ADDENDUM NO. 3

PROJECT NAME: Othmer Hall Machine Shop Renovation
UNL PROJECT NUMBER: 10151
BID INVITATION NUMBER: 2410-14-7200

Project Name: Othmer Hall Machine Shop Renovation

MODIFICATIONS TO THE DRAWINGS:

J4 HVAC PLAN
 M3.0 SCALE: 1/8" = 1'-0"

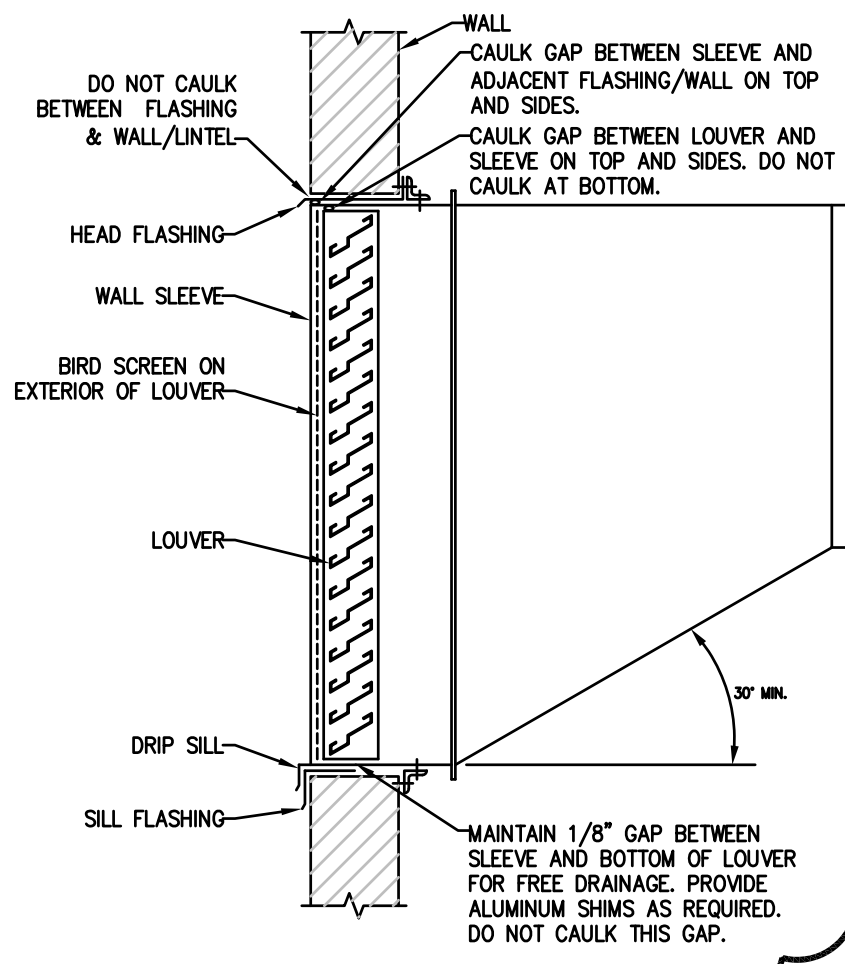
1. Sheet M3.0 HVAC Plan

- A. The width of the exhaust ductwork shall be modified as shown, see attachment M3.0-1.
- B. Section callouts have been added for clarification, see attachment M3.0-1.

F7 TYPICAL WALL LOUVER DETAIL
M4.0 SCALE: NO SCALE

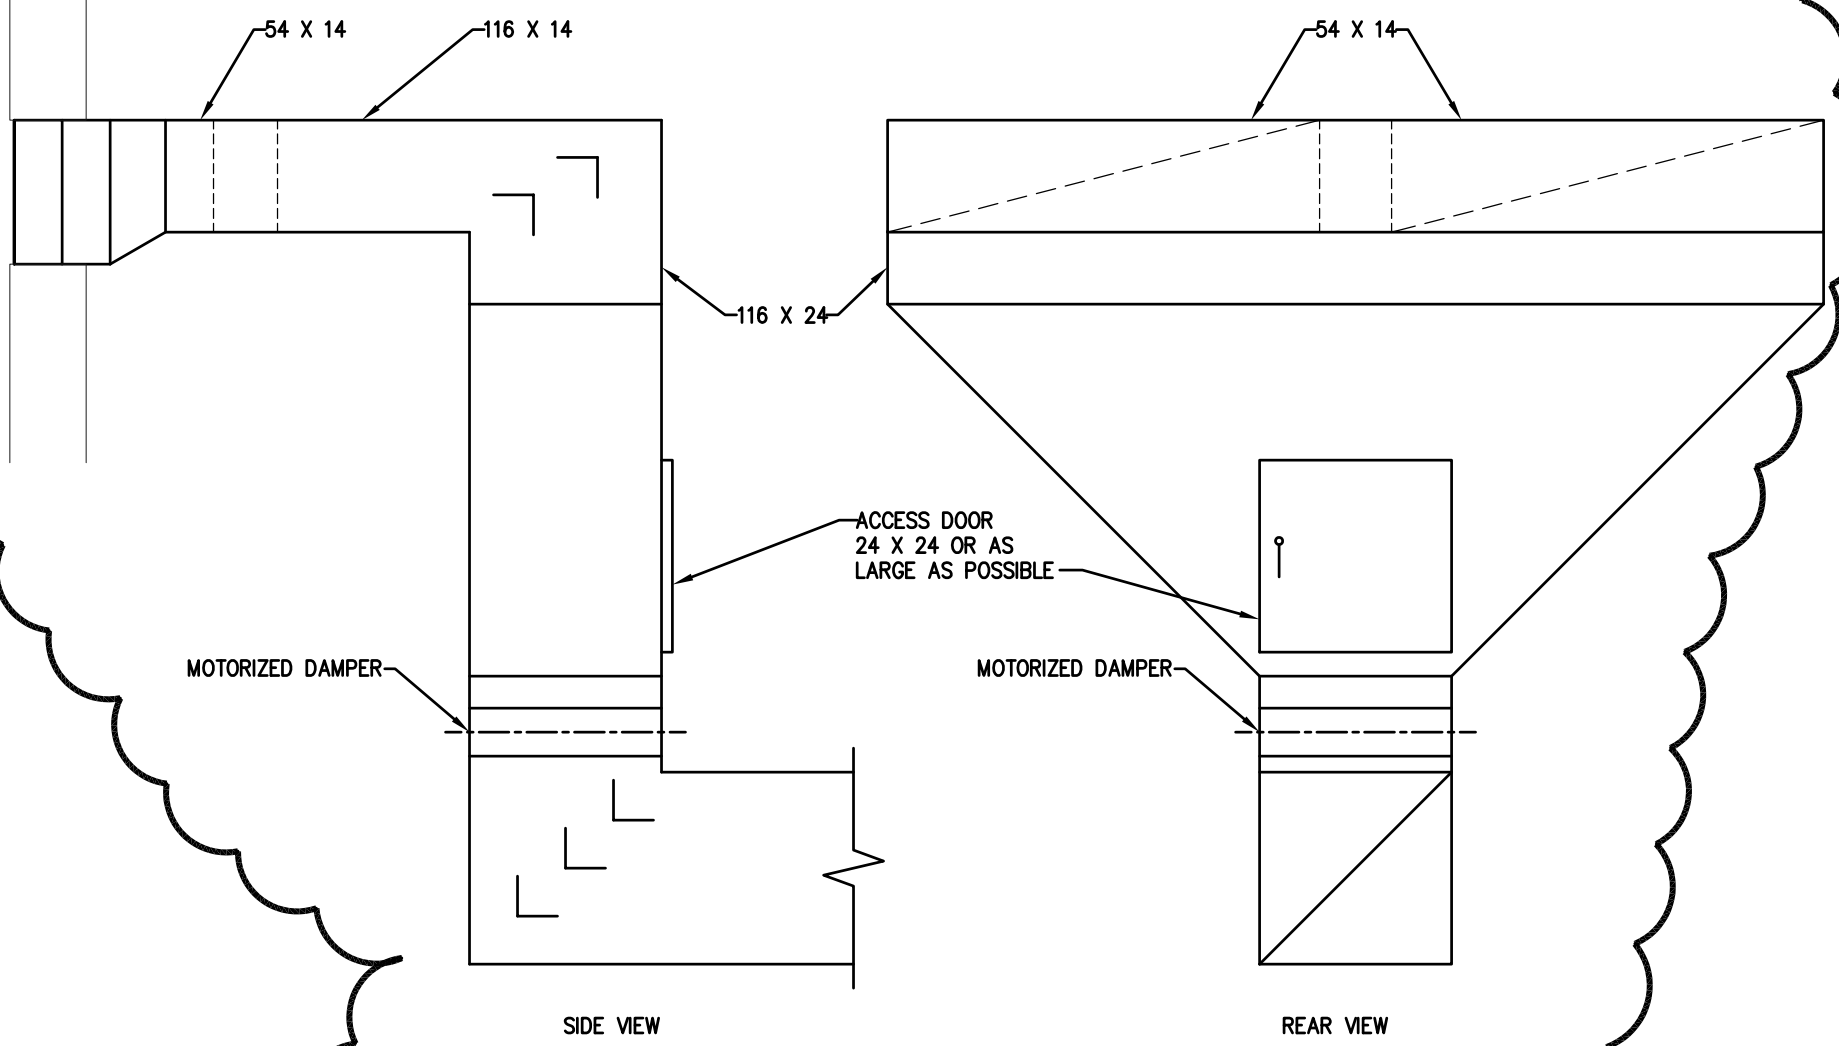
2. Sheet M4.0 Mechanical Details

- A. Typical Wall Louver Detail F7 has been modified, see attachment M4.0-1, detail F7.
- B. Exhaust Outlet Sections has been added for clarification, see attachment M4.0-1, detail K12.
